ADDENDUM #1 – AUGUST 5, 2025

RE: CHETCO COMMUNITY PUBLIC LIBRARY
Interior Improvements
Project #23.88.1

FROM: HGE ARCHITECTS, Inc.
333 South 4th Street
Coos Bay, Oregon 97420
541-269-1166

A-203 }

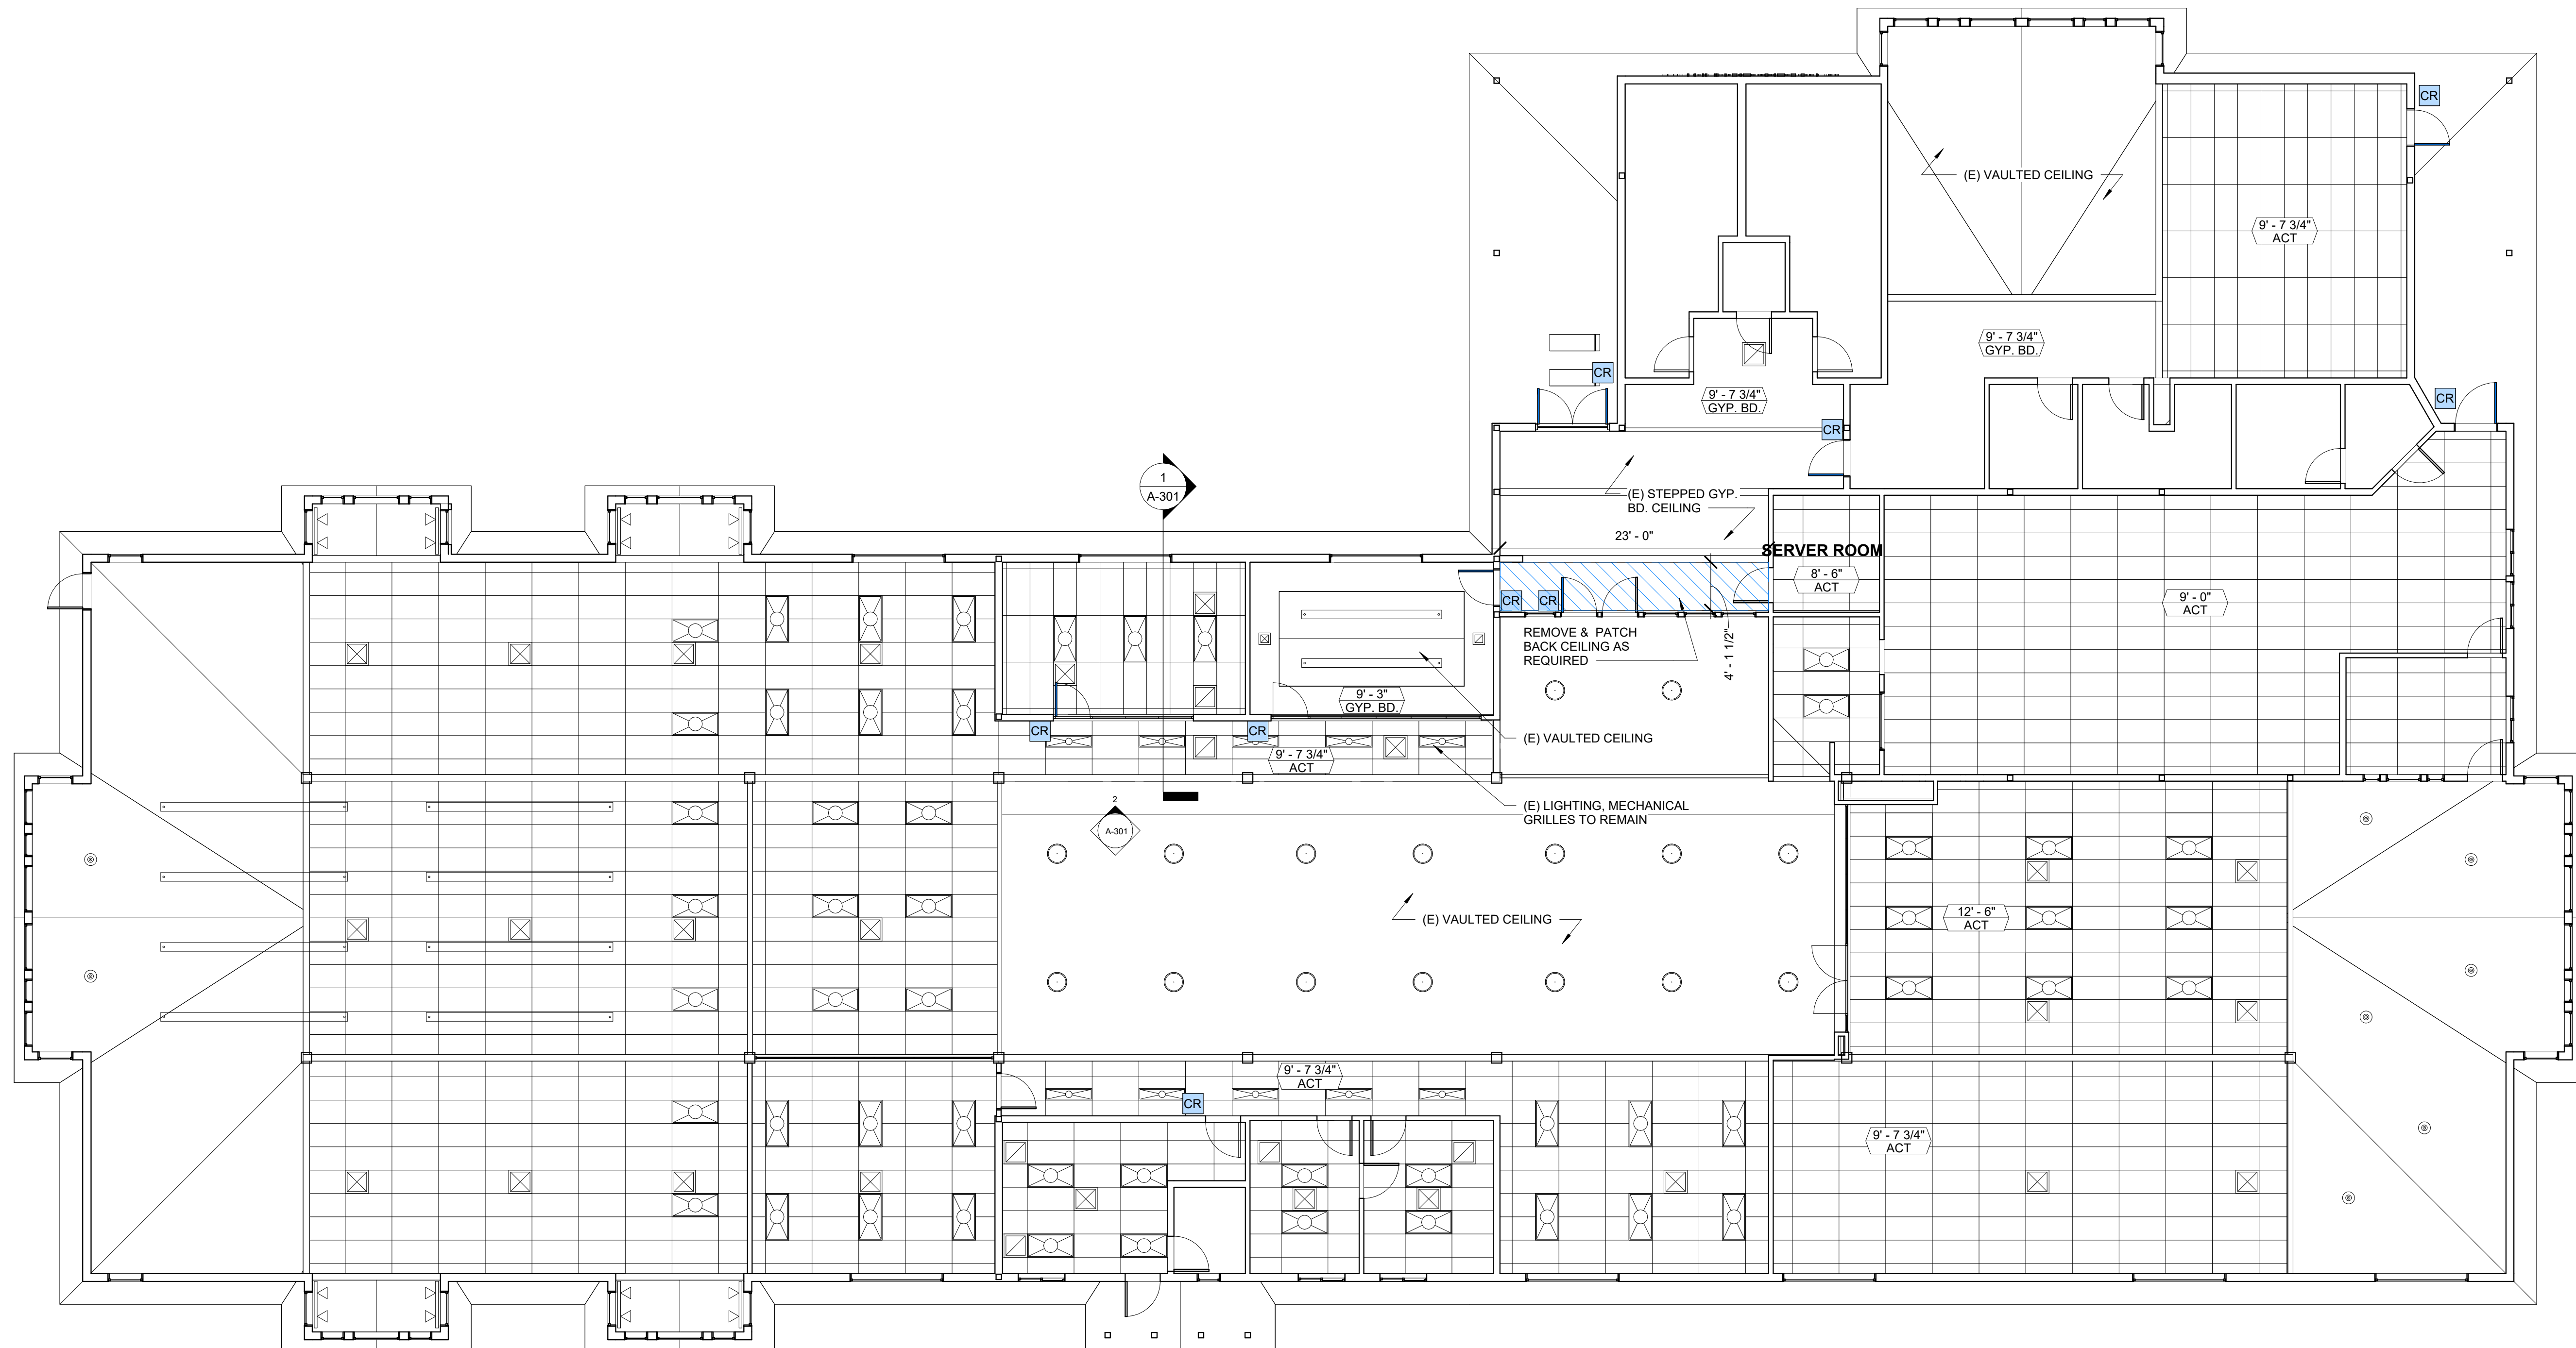
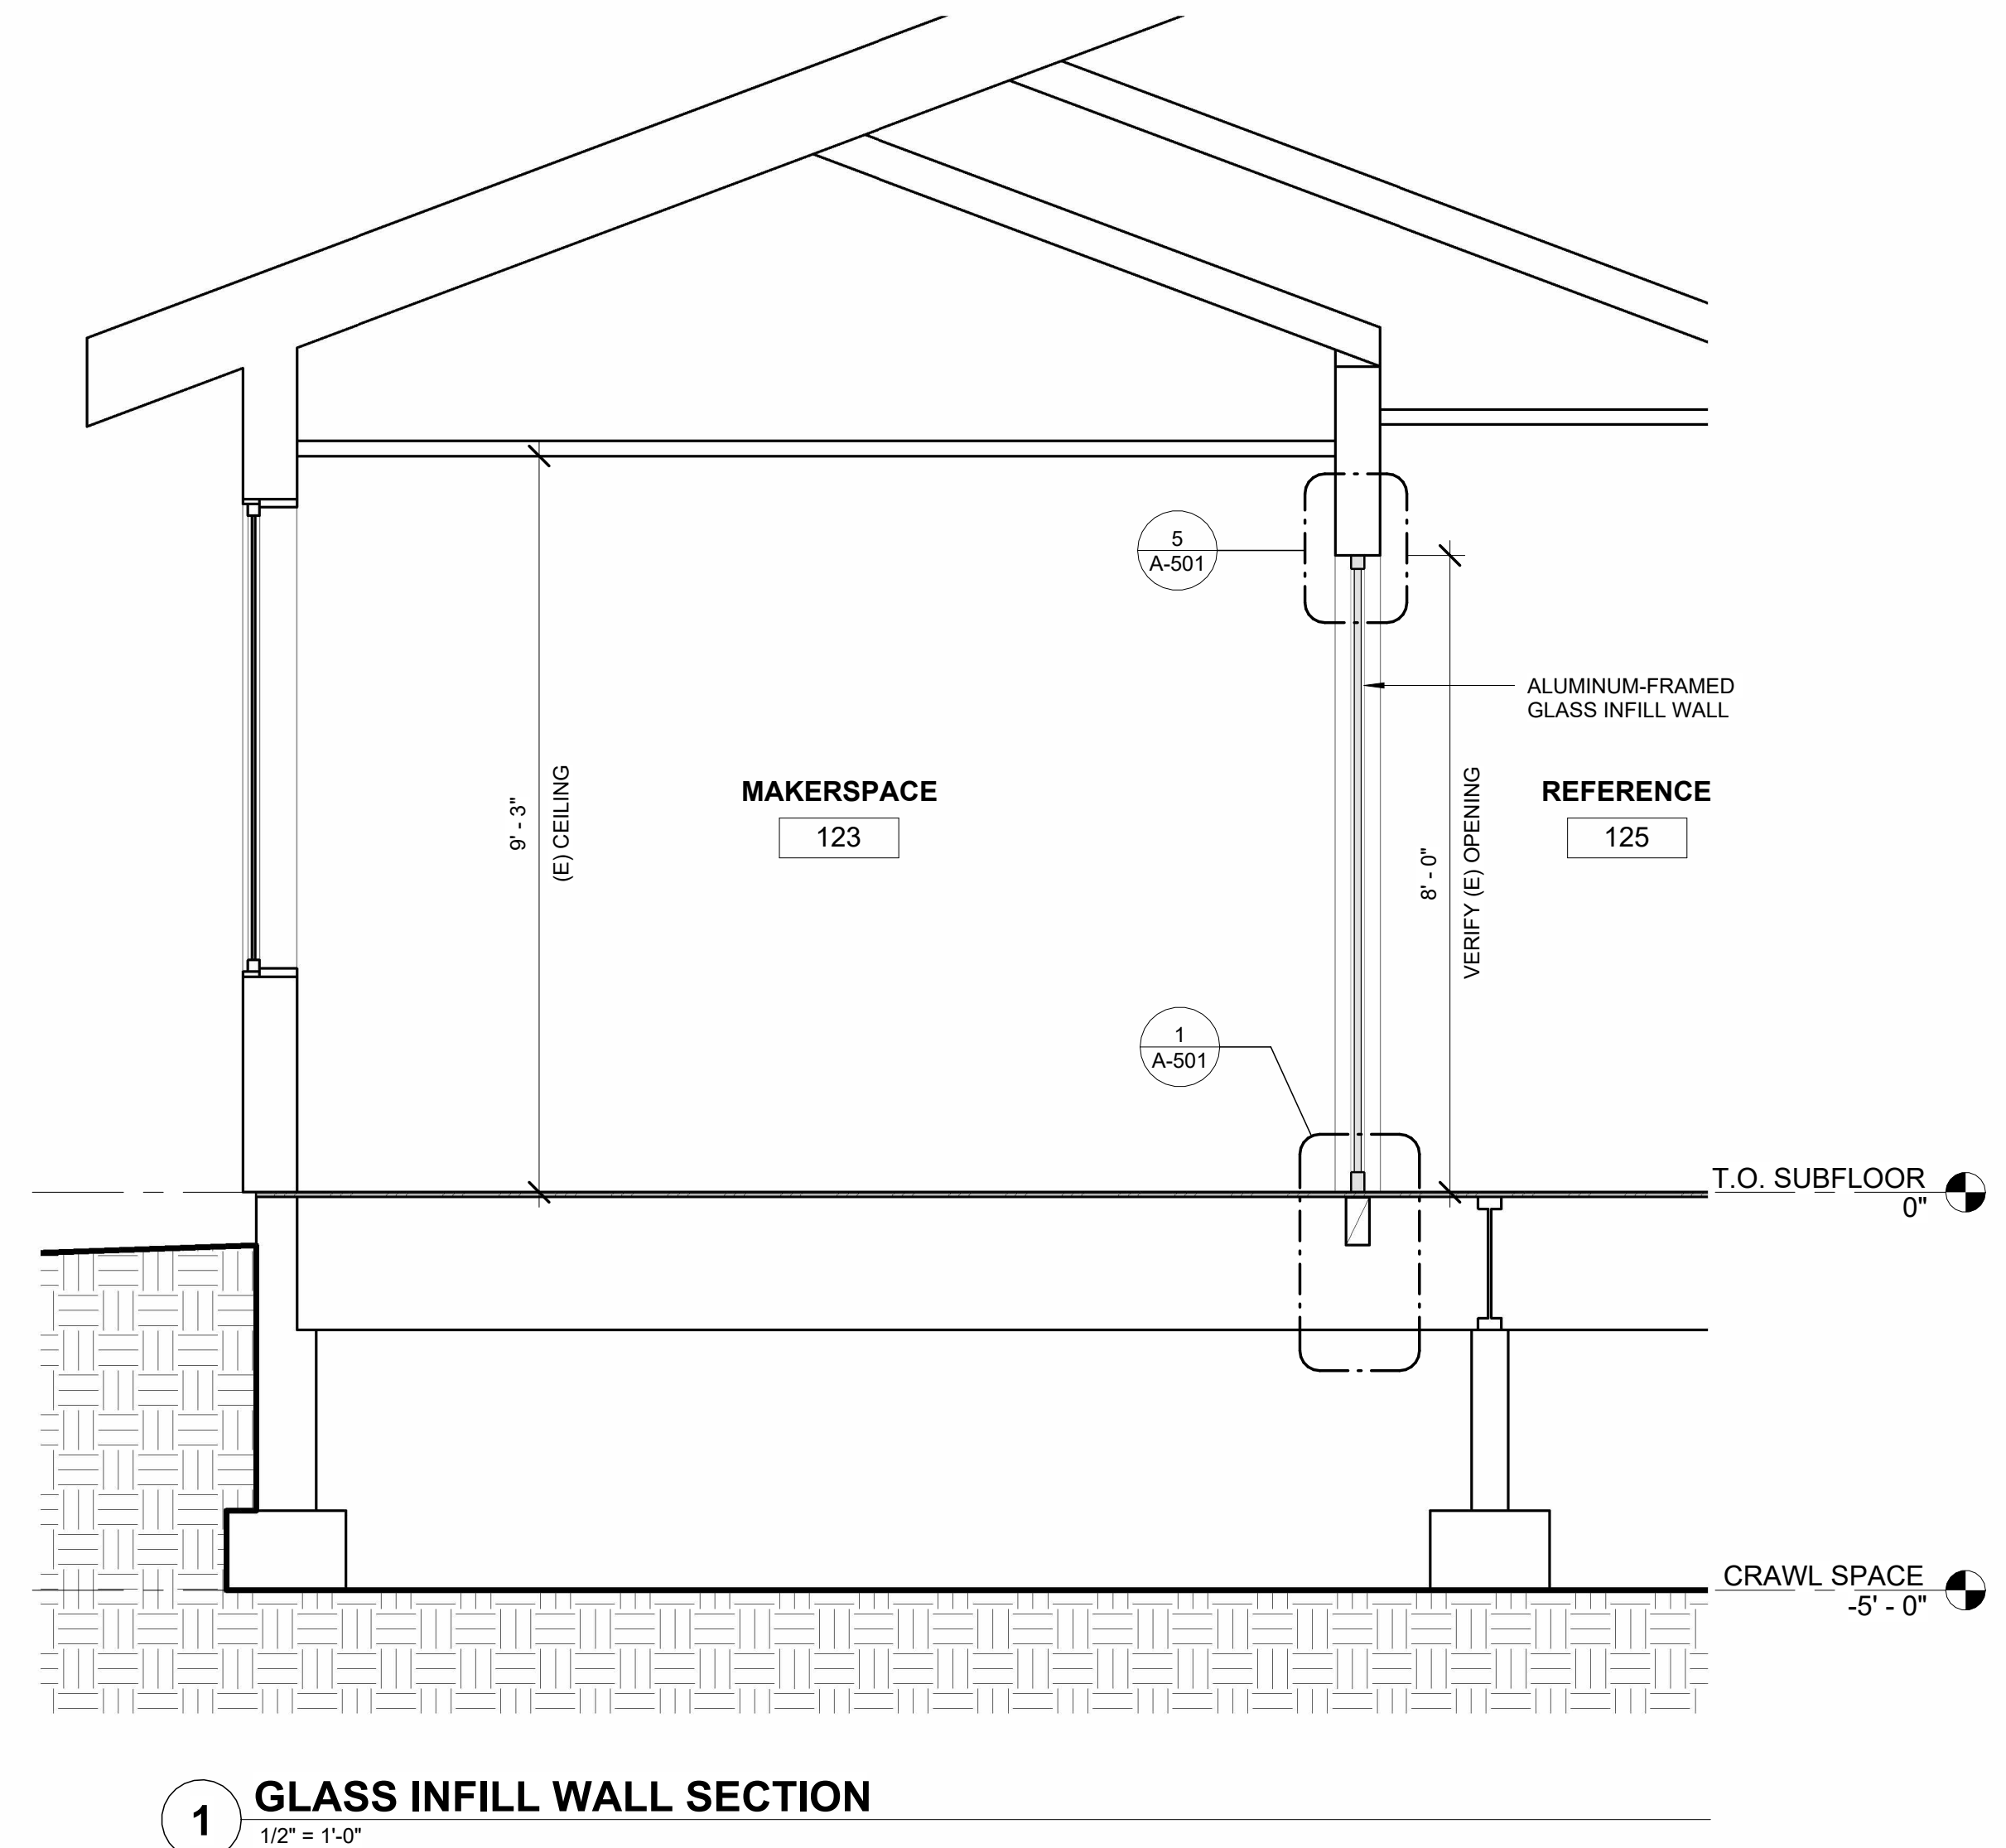
- b. DELETE General Note #3, “Access Control by separate vendor...”
4. **Sheet A-203 Library Reflected Ceiling Plan:** ADD attached Sheet in its entirety.
